# Technical Bulletin

94 07 02 May 10, 2007 2012799 Supersedes T. B. Group 94 number 06-17 dated Nov. 3, 2006 due to updated part and part installation procedure.

Headlamp Inoperative, Adaptive HID Xenon System

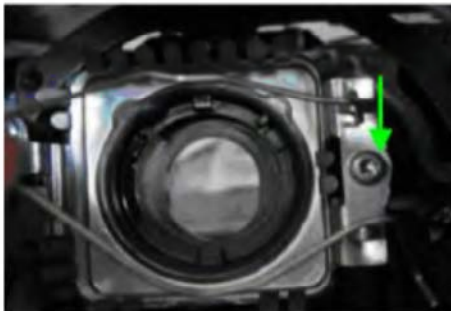
The factory harness routing may cause too much tension on the HID Bi-Xenon headlamp connector. When adaptive action (movement) is enabled, the HID Bi-Xenon headlamp wiring harness may disconnect from the HID Bi-Xenon bulb connector.

- Remove the affected HID headlamp Assembly. See Repair Manual Group 94 - Lights, Switches - Exterior.
- Access HID bulb wiring harness.
- Inspect for disconnected wiring harness terminal end connector at HID bulb.

If wiring harness is NOT disconnected:

- Further diagnosis is required.

If wiring harness is disconnected:

- Continue with repair.
